**RE: 248 Jared Lane**

I reviewed the drawings, evaluated the site context and prepared a review letter on this project last May. My comments and recommendations on the revised design are as follows:

*Proposed Left Side Elevation*

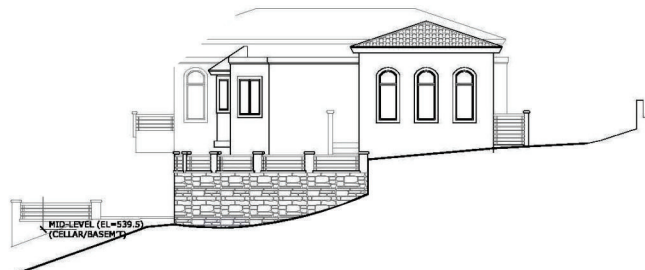
- The bay window is not well integrated into the design.
- The mansard tile roof is not characteristic of this architectural style.
- The terrace railings do not appear to be appropriate to the architectural style.
- The window frames, as drawn, look too narrow for this more formal architectural style.
- The left side elevation has only changed slightly from the design which troubled the Planning Commission.

If staff and the Planning Commission are still concerned about the side elevation appearing as a three-story wall, my recommendation would be to add stone the building base at the west end of the structure to visually separate the lower mass from the upper wall - see illustrations below.

### *PREVIOUSLY PROPOSED SOUTH ELEVATION*

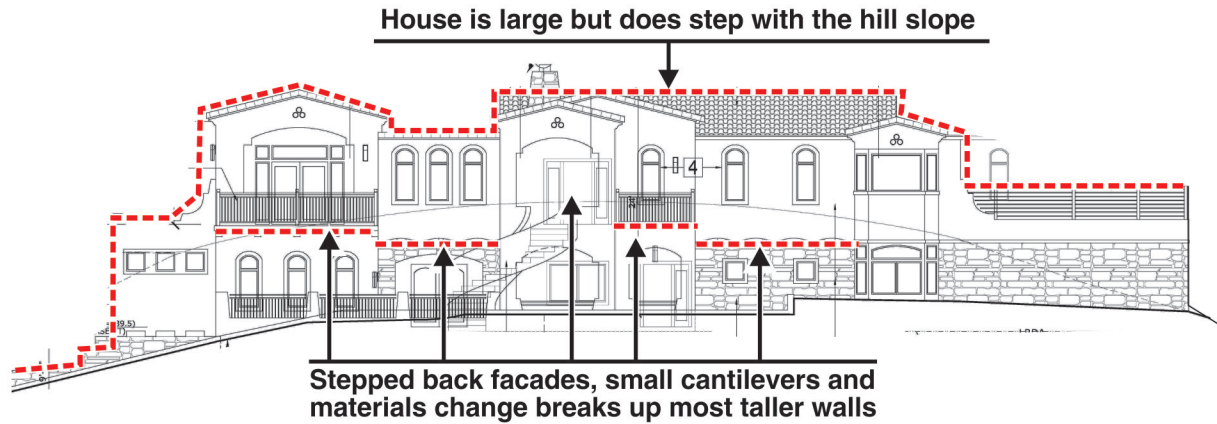
As noted above, my review of the previous design was positive based on the clear architectural style, substantial articulation and visual richness - see original diagram below.

I believe that implementation of the recommendations above would greatly improve the proposed design. However, I would opine that the previous design would be visually superior if the other changes desired by the Planning Commission could be incorporated to their satisfaction. The exterior entry stair approach recommended above could also be incorporated as shown in the elevation below.

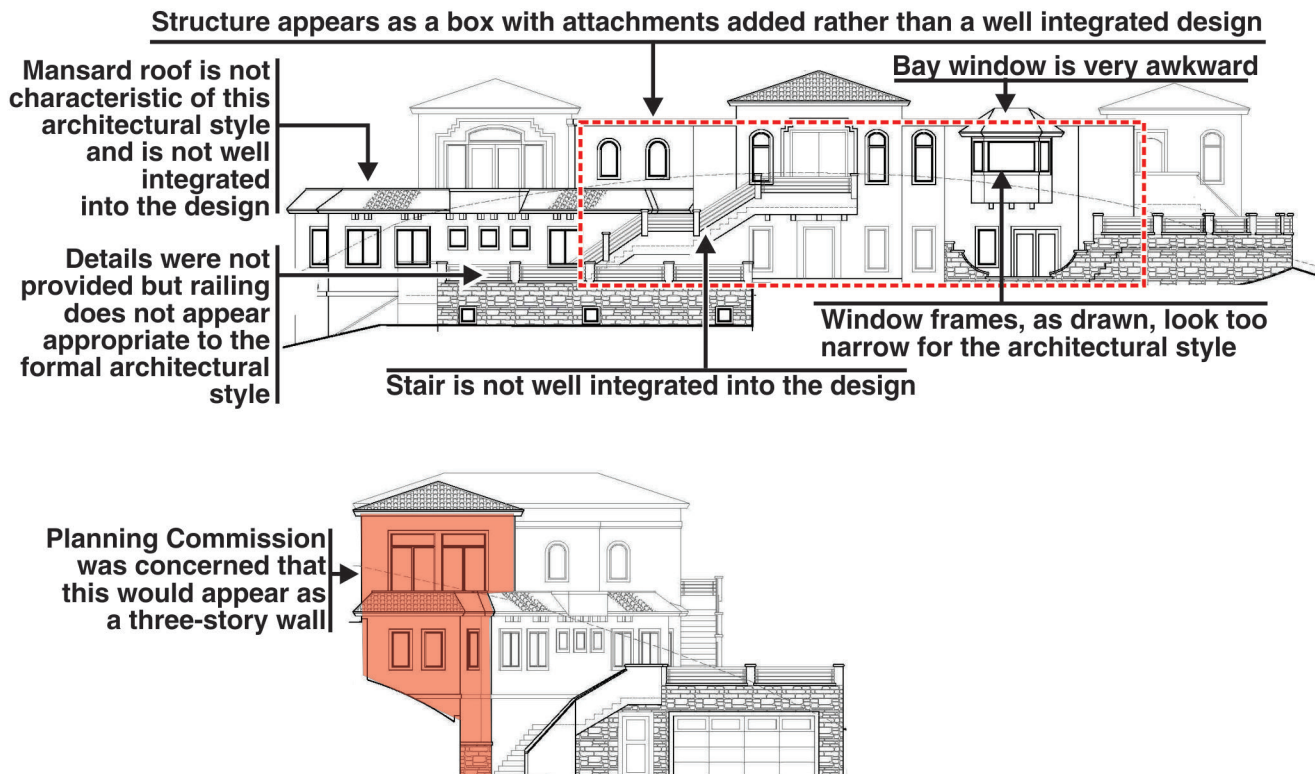
The revised design is, I believe, much less successful. Rather than having a visually interesting profile and articulated facade, the revision appears largely as a box with applied attachments. Some other specific issues include the following:

1. Increase the roof overhangs on the three main roof forms, and add corbels at the soffits.
2. Integrate the entry stair more into the overall building form to reduce its current added-on appearance.
3. Add balustrades which are consistent with the formal architectural style at the flat roofs and terraces.
4. Integrate the bay window with the balustrade and add supporting corbels and additional trim.
5. Use wider frames on all windows consistent with the formal architectural style.
6. Inset the window frames on all windows consistent with the formal architectural style.
